Contract #: 04-0120F4Cty: SF/ALA Rte: 80 PM: 13.2/13.9File #: 69.25B**QUALITY ASSURANCE -- NON-CONFORMANCE REPORT****Location:** Changxing Island, Shanghai, P.R. China**Report No:** NCR-000620**Prime Contractor:** American Bridge/Fluor Enterprises, a JV**Date:** 10-Jan-2010**Submitting Contractor:** Zhenhua Port Machinery Company, Ltd (ZPMC), Changxing Island**NCR #:** ZPMC-0593**Type of problem:**

To: AMERICAN BRIDGE/FLUOR, A JV **Date:** 11-Jan-2010
 375 BURMA ROAD
 OAKLAND CA 95607 **Contract No:** 04-0120F4
 04-SF-80-13.2 / 13.9
Dear: Mr. Charles Kanapicki **Job Name:** SAS Superstructure
Attention: Mr. Thomas Nilsson Project/Fabrication Manager **Document No:** 05.03.06-000583
Subject: NCR No. ZPMC-0593

Job Name: SAS Superstructure

Project Name: S.F.O.B.B 项目名称: 美国加州海湾大桥		NCR Number: NCR 编号: NCR-B-391(ZPMC-0593)
Item: Unacceptable straightening 名称描述: 直线度超标	Item Number: 件号: 5AW+5BW	Drawing: 图号: EP043
Location: Trial assembly 5W 位置: 后场总拼 5W		Date: 日期: 2010-01-18

Reference Description: Straightness/flatness deviation outside of allowable tolerance noted at Open rib Stiffener to Open rib Stiffener joint (Edge Panel of 5AW to 5BW)

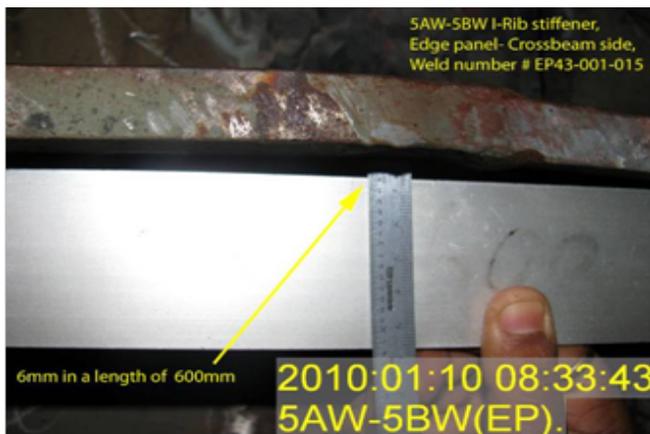
- One I-Rib weld between the 5AW to 5BW (Edge panel-I-Rib stiffener) was misaligned across the weld joint.
- The Edge Panel (EP) I-Rib stiffener weld joint is identified as: EP043-001-015 (Cross beam side)
- This weld is complete joint penetration (CJP) butt weld.
- The material is designated as non Seismic Performance Critical Members (Non SPCM).
- The out of flatness measurement across the weld joint is 6mm over a length of 600mm, where the 600mm ruler is centered over the weld joint. The maximum allowable deviation per the Standard Specifications is 5mm.

-Per AASHTO Bridge Construction Specifications, the straightness of longitudinal stiffeners issue was observed. A maximum deviation of 8mm was measured over a length of 2500mm by placing a fully tensioned string line adjacent to both ends of the stiffener where the diaphragm/floorbeam intercepted the stiffener. The maximum allowable deviation for straightness is $L/480$ ($2500/480$) = 5.2mm

焊缝返修位置示意图:
Draft of welding discontinuity:

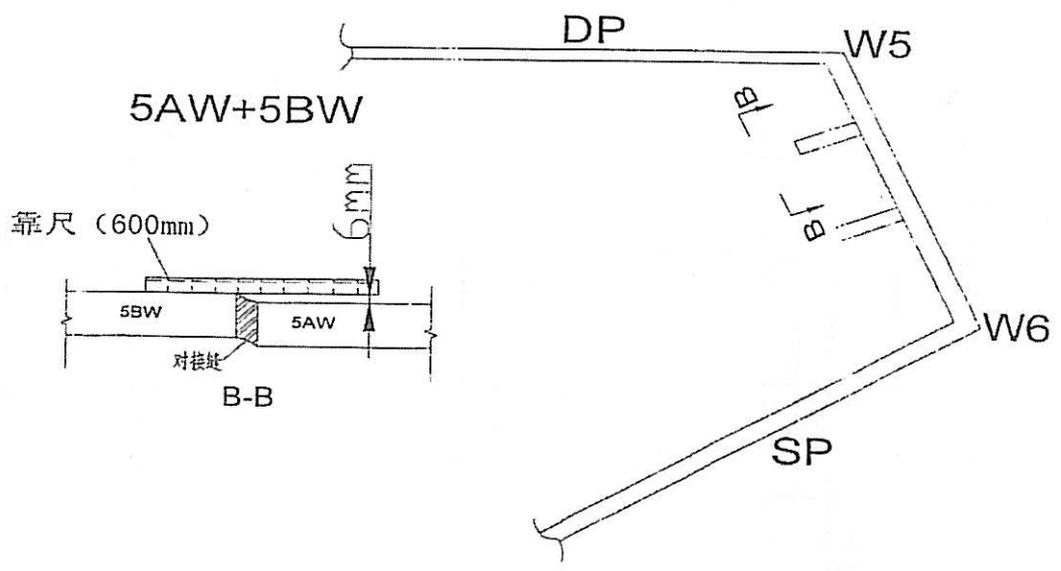
焊缝缺陷描述:
Description of welding discontinuity:
 经检测发现: 5AW+5BW (焊后) 靠联系梁侧斜腹板上有一处I肋对接存在错边。详见如图所示:
 It was found that one "I" rib on the web plate next to the connection plate in Segment 5AW+5BW was misaligned after welding. Please see the details in the following sketch.

1. 采用打磨或碳刨的方法去除对接端口处I肋与腹板之间部份长度焊缝, 去除焊缝长度根据实际情况定。同时用切割的方法去除I肋的对接焊缝。碳刨前根据相应WPS预热;
 2. 采用外力调整对接端口I肋斜势不大于1: 10, 对接错边量在公差范围内。
 3. 根据相应返修WPS准备焊接接头;
 4. 根据相应WPS预热及返修;
 5. 将返修处焊缝打磨与周边焊缝平齐;
 6. 根据图纸要求进行检测。
-
1. Remove the welds between I-Ribs and the edge plate at the splice by grinding or gouging. The length of removed weld will be decided according to actual situation. Meanwhile, remove the butt weld between I-Ribs by cutting. Preheat according to the WPS prior to gouging.
 2. Adjust the misalignment of I-Ribs to meet the tolerance. The transition is not more than 1:10.
 3. Prepare the excavation according to the relevant WPS.
 4. Preheat and weld according to the WPS.
 5. Grind the weld flush to the adjacent weld or base metal.
 6. Check the weld according to the shop drawings.
